PRODUCT CHANGE NOTIFICATION

#PCN-DC-JKR0-14

Business Unit	Product Line Code	Type of Change	Action	Date of issue
DC	AAB	Mechanical	Notify Distributors and Field	3/3/2014

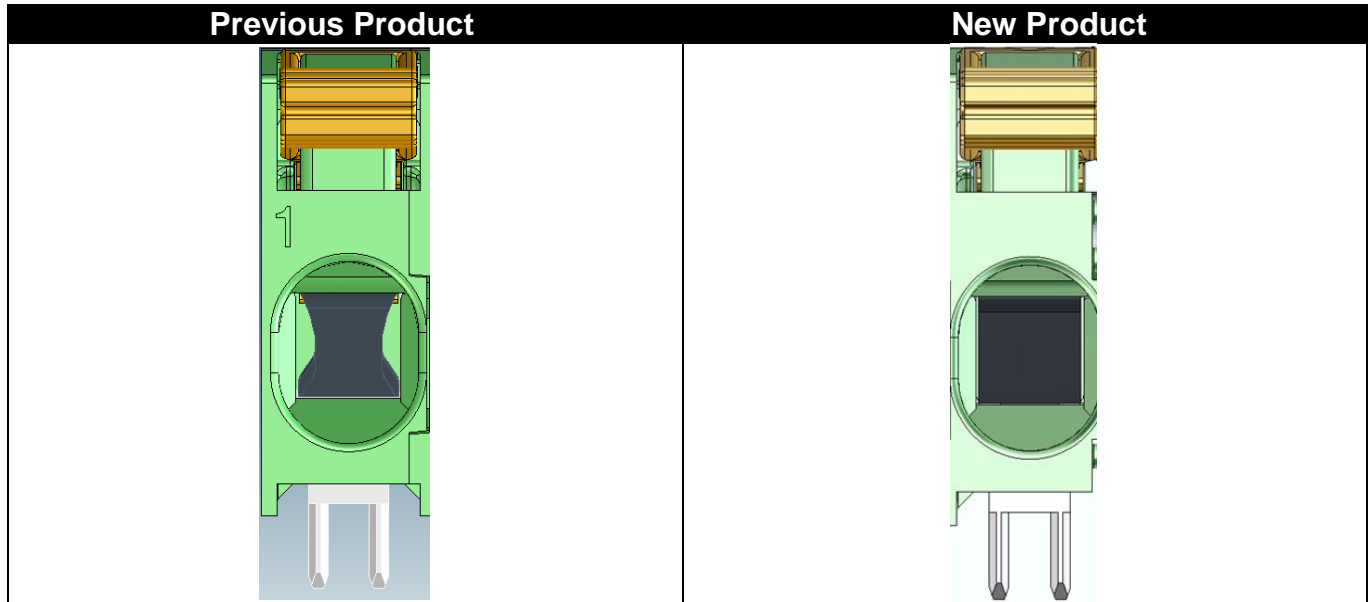
Due to our continuous improvement process, the contact spring has been made wider in the contact area. This improvement allows for a better production process.
